**ADDENDUM NO. 1**

Date: October 11, 2022

**Project: RFQ/P # 460  
Cesar Chavez / Edward Kemble New Construction and Modernization**

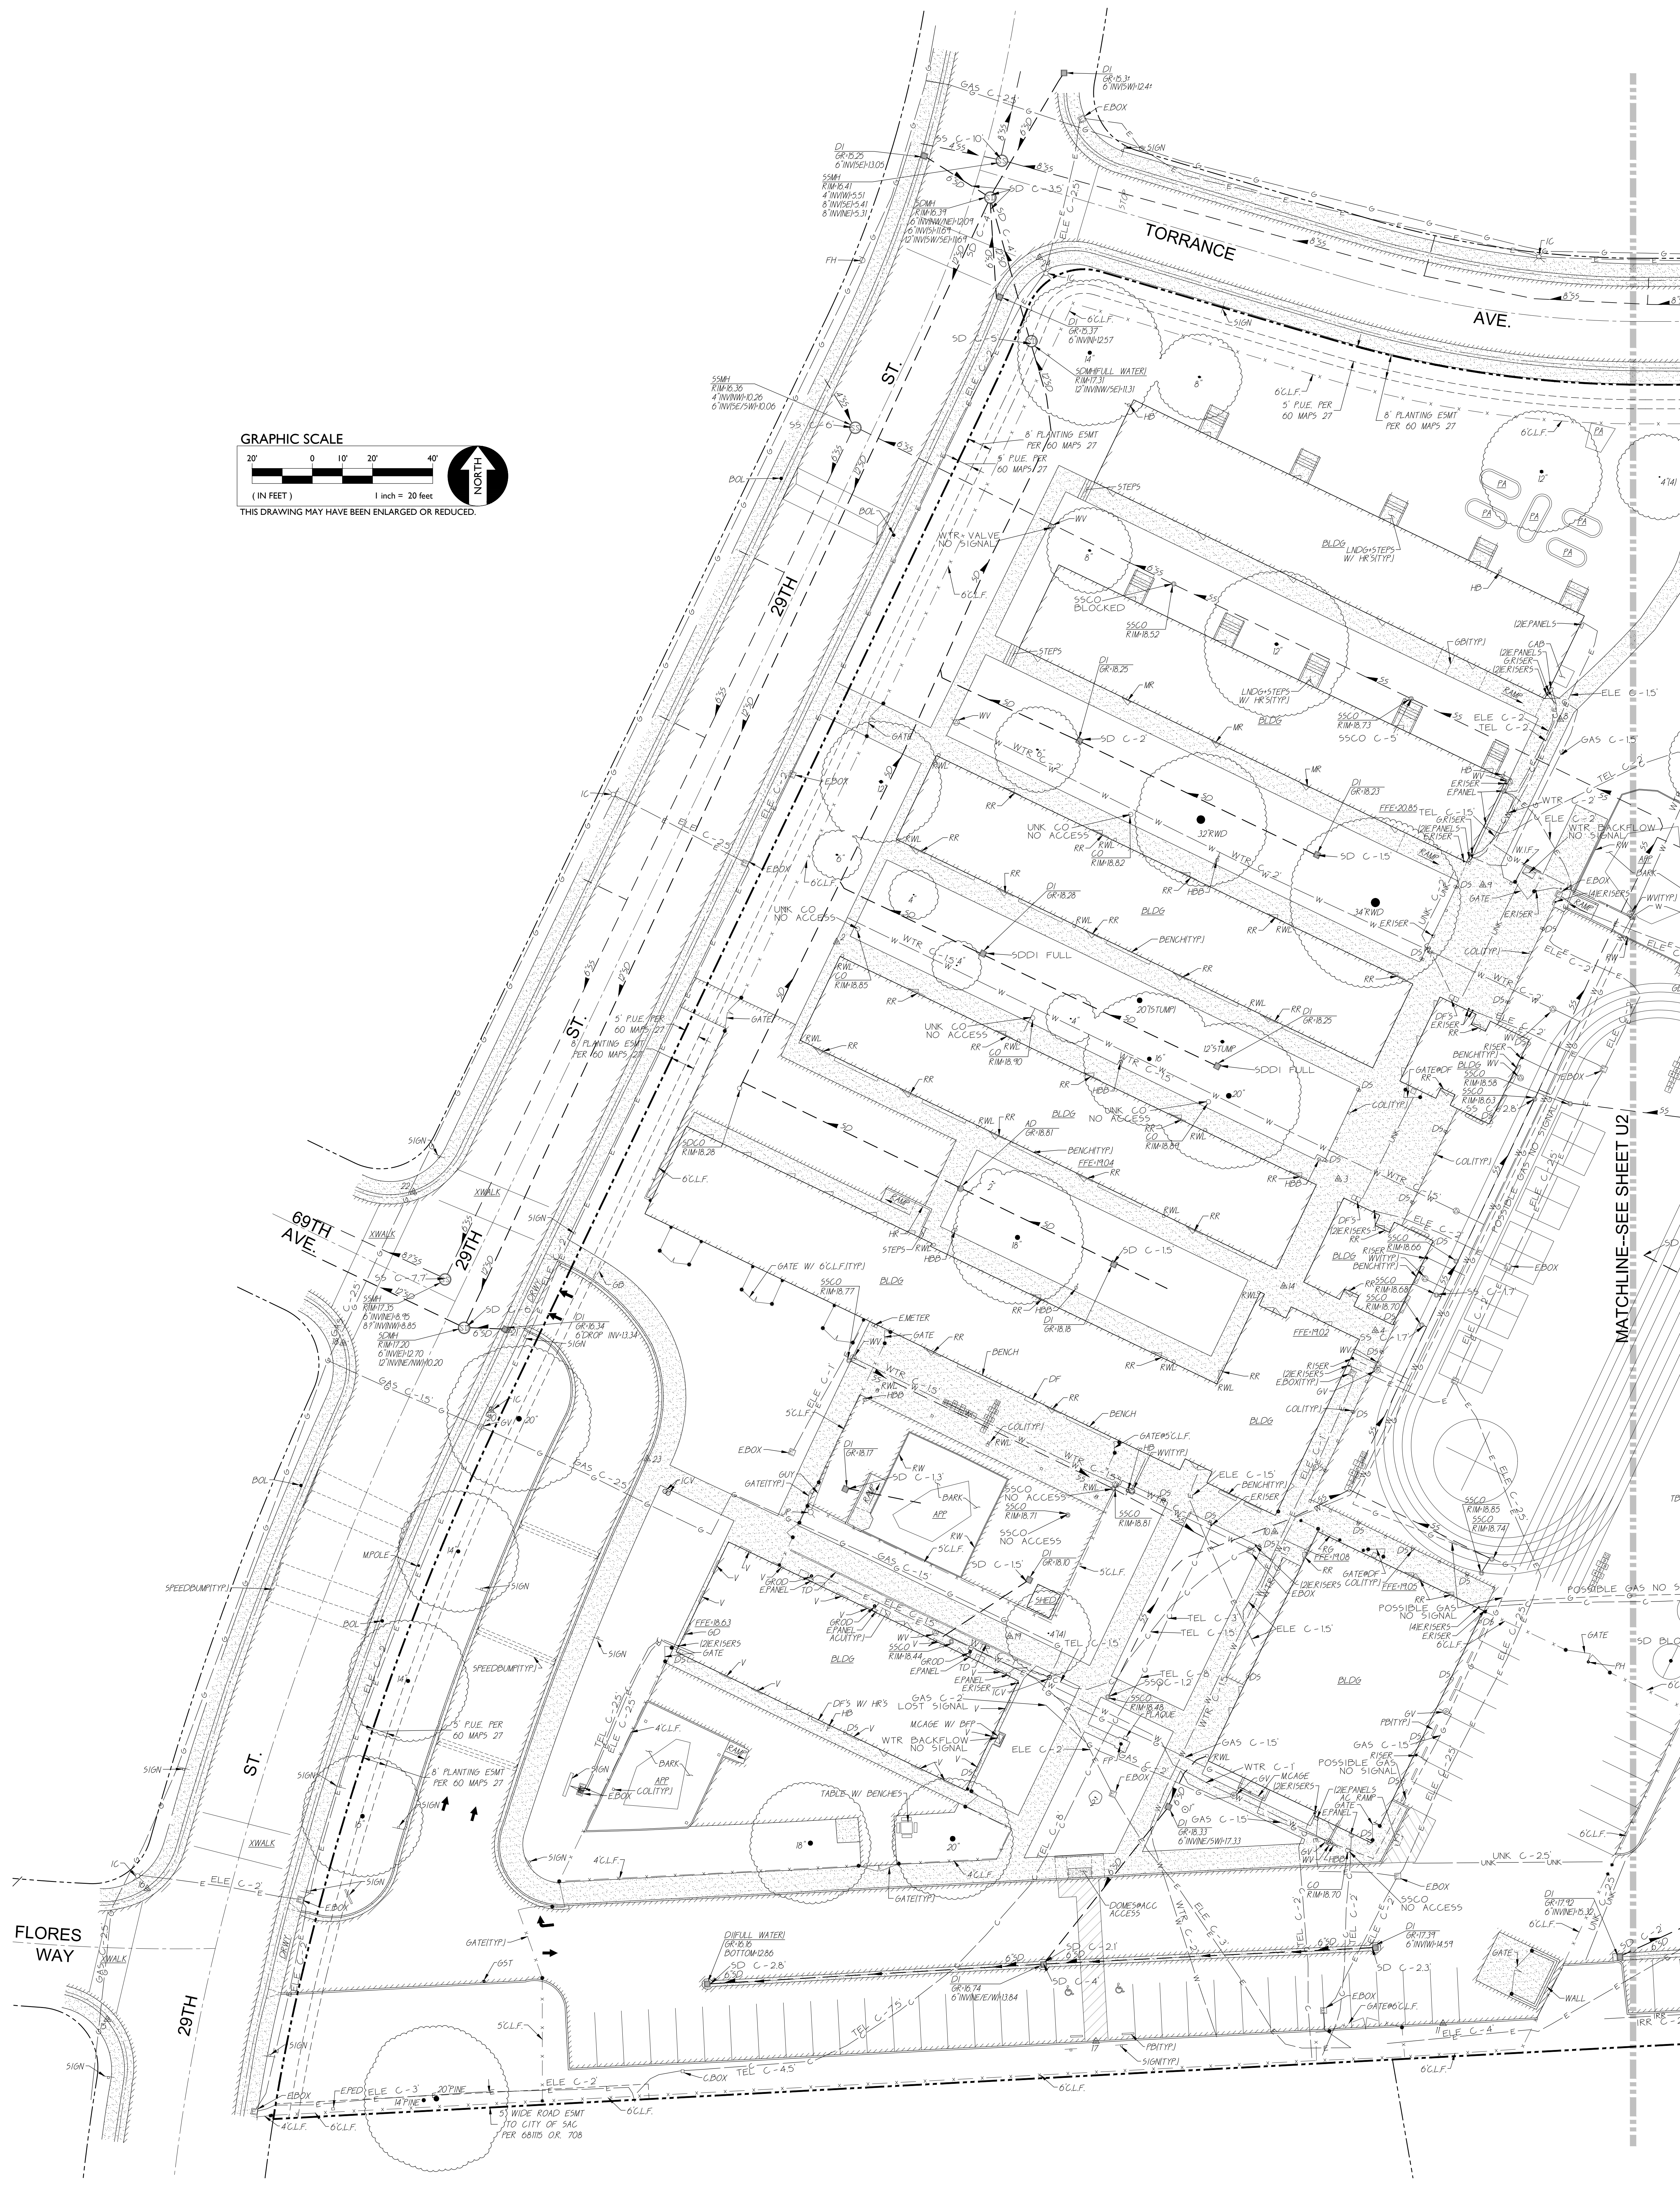
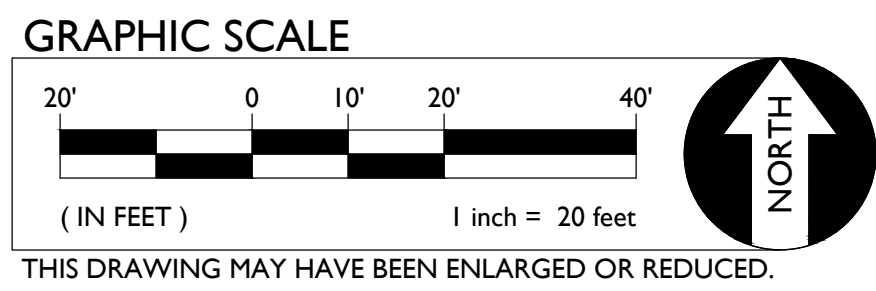
**Question #5:** Is there an existing utility plan that we can utilize during the proposal phase?

**Question #6:** Are there any better developed civil plans that can be shared and we can utilize during the proposal phase?

**Response #5:** Yes, see attachment AD1.09 – Cesar Chavez/Edward Kemble TOPO.

**Response #6:** Yes, see attachment AD1.09 – Cesar Chavez/Edward Kemble TOPO.
